Subject ▶ Addition of sponge sheet to handle

For Models ▶ 9005B, 9006B, 9005BS (Disc Grinders)

▶ Current	▶ New
U.S.A., Guam, Canada, Australia, Netherlands, United Kingdom, Italy, Greece, Austria, Finland, France, New Zealand, Reunion, Algeria		
Other countries

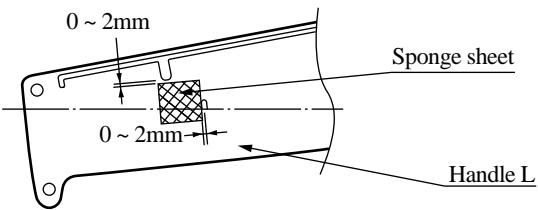
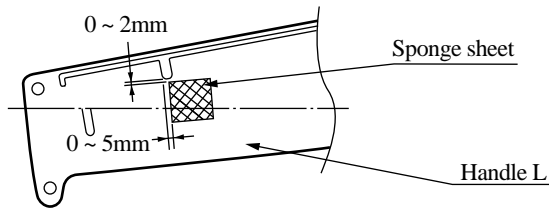
Description ▶ As illustrated below, sponge sheet has been added against damage to power supply cord.

Interchangeability mark : <= means that the new part can be substituted for the current. The current handle set can be used for replacement when you paste the sponge sheet to it. The new handle set is supplied to you with the sponge sheet pasted.
